Re.: Conservation Northwest Objection to the North Fork Nooksack Vegetation Management Project Draft Decision

Project Name: North Fork Nooksack Vegetation Management Project

Aspects of the Proposed Project Addressed in this Objection

Debris Slide on Canyon Creek Road, October 28, 2021 (this slide was not there when I went up the mountain)

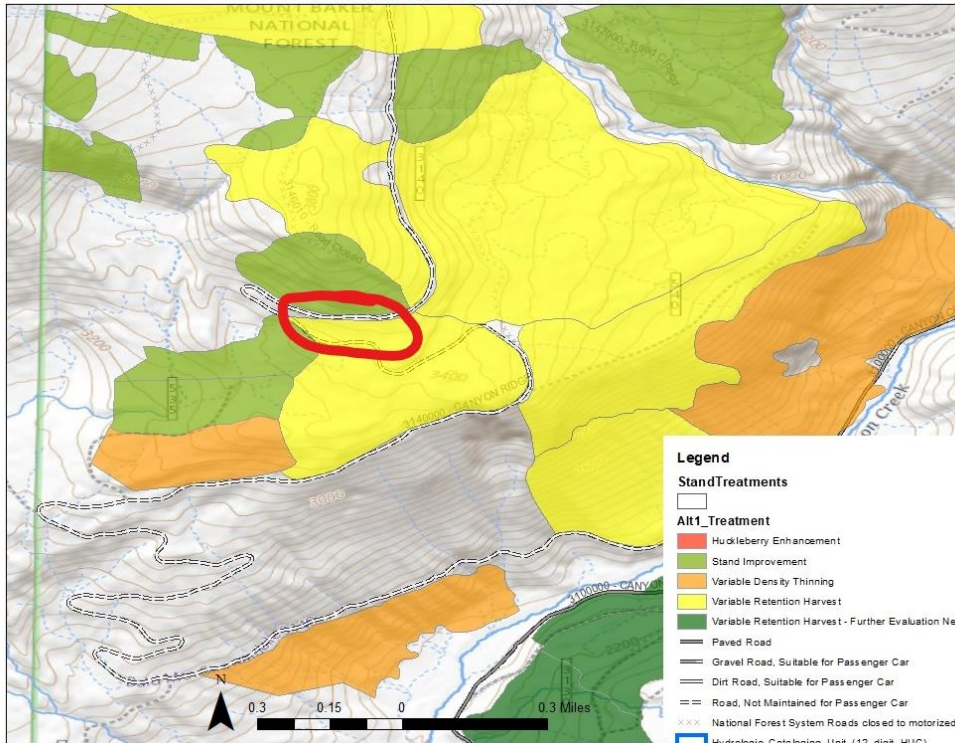
Stream stability is poor in much of Canyon Creek with large portions at high risk for instability (CCWA p. 105); see also Appendix A. Several studies confer that 50% of sediment contribution to streams in the Canyon Creek subwatershed is associated with mass wasting events and only 10% of these occurrences are natural; the majority are associated with roads or clear cuts and occur as debris flows or debris slides (CCWA p. 41). It is difficult to reconcile how doubling the recommended threshold of vegetation removal/canopy disturbance in this subwatershed would ensure negligible effects on water quantity and normal-range stream flows as required by the Aquatic Conservation Strategy (NWFP B-11). Though not expected to move to “poor/impaired” condition post-treatment, Canyon Creek and Hedrik Creek-NF Nooksack River subwatersheds are currently in “fair/at risk” condition and will be further degraded for up to 5 years during timber contracts (Final EA p. 39). Furthermore, if “we expect to see higher frequency of flooding and high flow events in the project area” due to climate change effects and increased rain on snow events (Final EA p. 22, 43), should the project not reduce the amount of vegetation treatments/disturbance to accommodate these anticipated events?
